Certificate of Appropriateness
BAR # 24-08-04
809 Locust Avenue, Tax Map Parcel 510019000
Martha Jefferson HC District
Owner: Sarah and Thomas Shafran
Applicant: Julie Dixon / Rosney Architects
Project: Addition and alterations to the primary elevation

**City of Charlottesville
Board of Architectural Review
Staff Report
August 20, 2024**

**Certificate of Appropriateness Application
Historic Conservation District**

BAR # 24-08-04
809 Locust Avenue, Tax Map Parcel 510019000
Martha Jefferson HC District
Owner: Sarah and Thomas Shafran
Applicant: Rosney Architects
Project: Addition and alterations to the primary elevation.

809 Locust Ave: From applicant's submittal

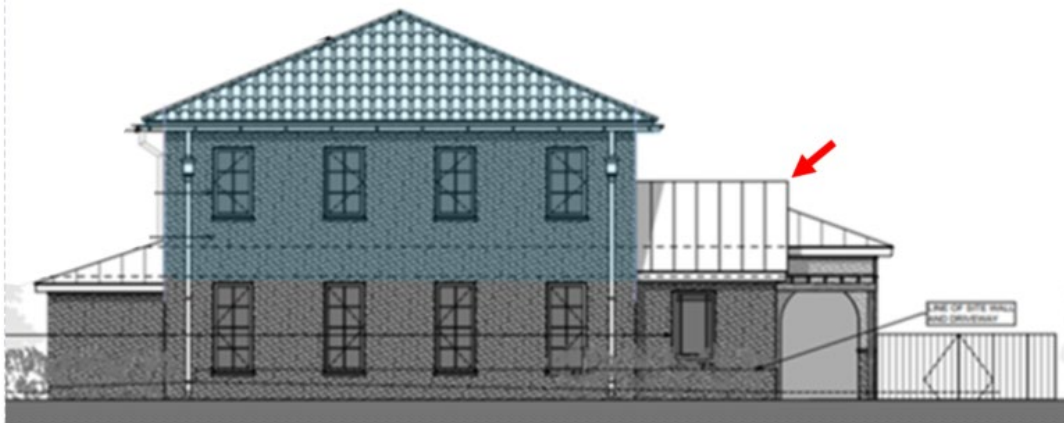
Staff recommends approval of the CoA. Primarily because the exterior of this house has been altered significantly since the 2004 survey of the Martha Jefferson HC District. The proposed alterations are consistent with the Design Guidelines for Historic Conservation Districts, and they are compatible with nearby dwellings, see Appendix. The site, relative to the front yard, will be unchanged.

Within an HCD, the BAR’s purview is limited to what is visible from the public right of way. Additionally, this dwelling is sited approximately 100-feet from the right of way--double what is typical for this side of Locust Ave.—and the grade at the house is 10-feet below the street. With those in mind, staff recommends the BAR focus its review on the primary façade.
